CERTIFICATE OF APPROPRIATENESS

Property: 1604 North Boulevard, Lot 8, Block 2, Edgemont Subdivision. The property includes a historic Mediterranean style residence, with 8,661 square foot of living space and is situated on a 15,000 square foot interior lot.

Proposal: Alteration – Addition

Construct a skylight on the front elevation above main entrance that is taller than the residence; a second story addition over garage; and change out doors and windows on all elevations.

SOUTH ELEVATION – FRONT FACING NORTH BOULEVARD

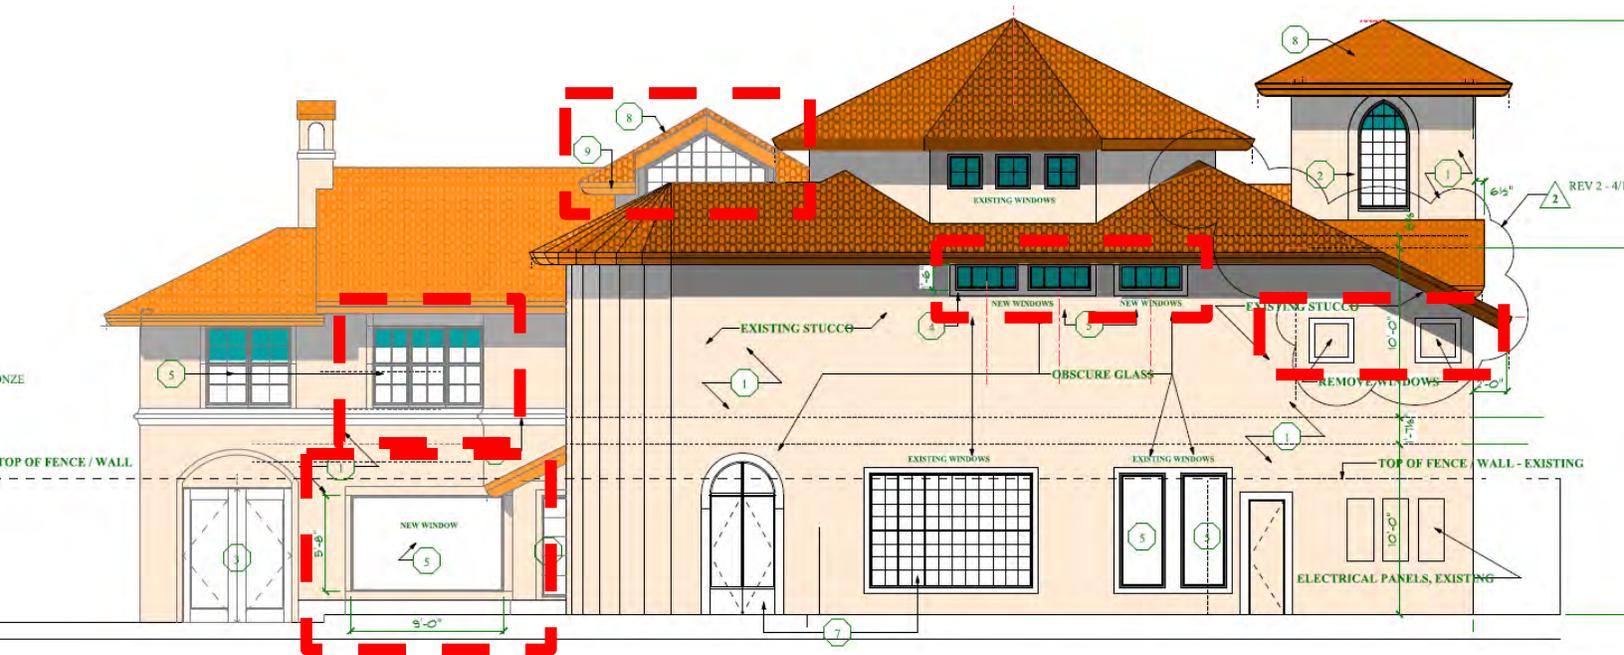
(b) The proposed activity must match the architectural features, materials, and character of either the existing noncontributing structure or the contributing structures within the context area.
The addition of a "dormer skylight" to this structure does not match the existing house, nor is it compatible to the style of architecture, historic character and the appearance of contributing structures in Boulevard Oaks Historic District. Furthermore, the skylight will be highly visible on the roof facing the street.

3. I believe that the new plans likely violate the objective height limits imposed by the Edgemont deed restrictions. Not shown the front elevation drawing that was submitted to establish height compliance by reference to an apparent “dormer” in that drawing, are the skylights that are shown, in another drawing, to obtrude above the peak of the apparent “dormer”. The Architectural Committee advised the 1604 North Boulevard property owner’s architect of this concern about height violation when it responded to the second set of plans, but the third set of plans did not address this concern and there has been no other response to that question.

4. What appears to be a “dormer” in the front elevation drawing is actually the front prow of a new north-south roofline that is to be topped with the protruding skylights. There is nothing like that in all of the Boulevard Oaks Historic District, and nothing like that should be allowed unless it can be demonstrated that it would not be visible from outside the property.

WEST SIDE ELEVATION

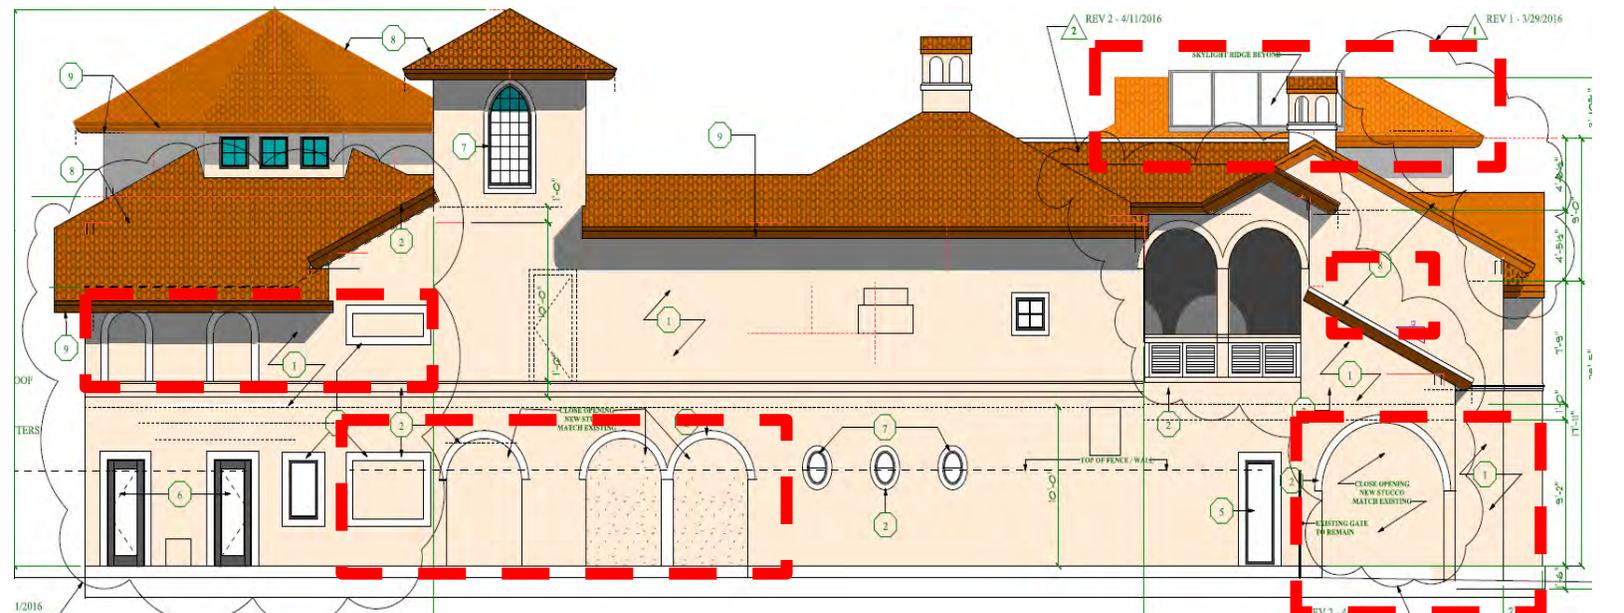
2. The structures at 1604 North Boulevard are already massively invasive of the side property line setbacks prevailing throughout the Boulevard Oaks Historic District, to the substantial detriment of the property owners to the immediate west of 1604 North Boulevard. I object to the huge and virtually unrelieved wall that is now proposed for the west façade of these invasive structures.
